This is to certify that SHALOM HOUSE INC / TE
has permission to Multi-Family new 24 unit apartment building with underground parking
AT 98 GILMAN ST 065 D003001

RE: Valley Street Apartments
Gilman Street
Portland, Maine

Enclosed are responses to the comments in your email of Friday, Wednesday, January 20, 2006.

DRAWING: ALTERNATING TREAD
 STAIRS

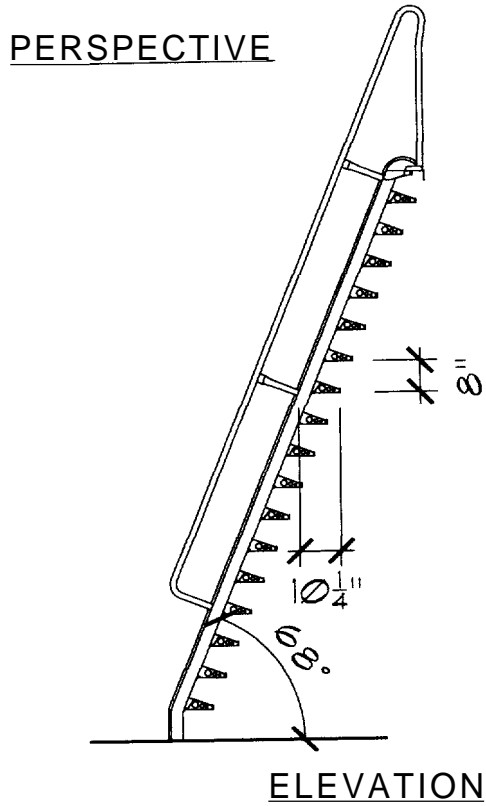
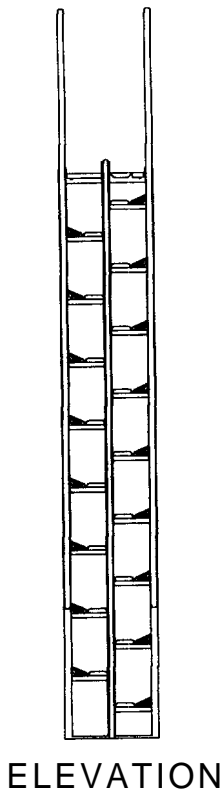
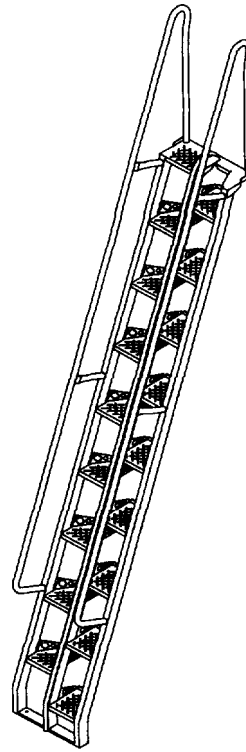
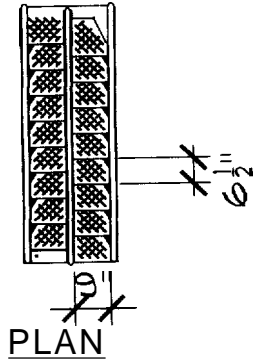
Alternating Tread Stair: see sketch attached and a letter from the ICC provided by the manufacturer.
